TO: Zoning/Planning Board  
FROM: Edward Tencza  
SUBJECT: Care One Management, LLC, 3641 Lawrenceville Road  
Block 6601, Lot 2

**SUBJECT:** Use and Bulk Variance Application No. ZB-1/22  
Minor Subdivision Application SP-2/22  
Major Site Plan - Preliminary & Final Application No. SP-3/22  
CareOne at Lawrence - Assisted Living Facility  
Tax Map Page 66.02 & 66.04, Block 6601, Lot 2  
Zoning Board Memorandum #2  
Lawrence Township, Mercer County, New Jersey

### **Review Comments**

Ladder Tower 23

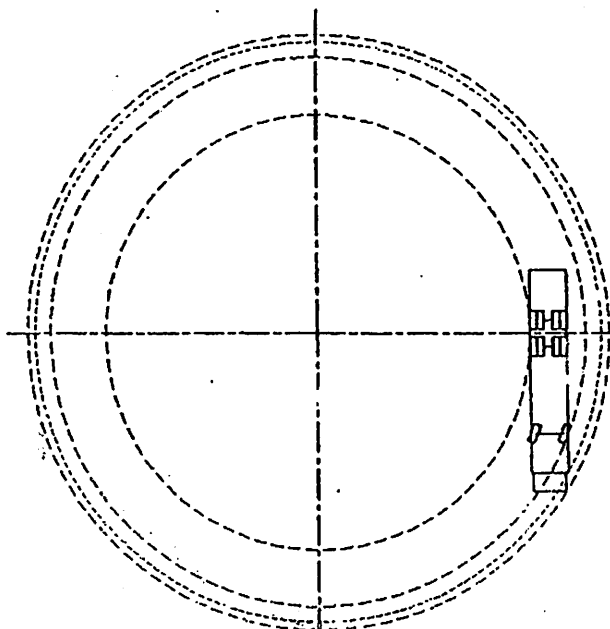
1. The Firetruck used in Site Plan for Truck Turning Exhibit does not match the two Tower Ladders that Lawrence Township currently operates. Tower 23 is a 1993 LTI 100' rear mount platform ladder, with a wheelbase of 256" and 25 degree turning angle and Tower 21 is a 2015 Seagraves 100' rear mount platform ladder, with a 234" wheelbase and 36.5 degree turning angle. The Firetruck used in Site plan has a 45.5 degree turning angle.
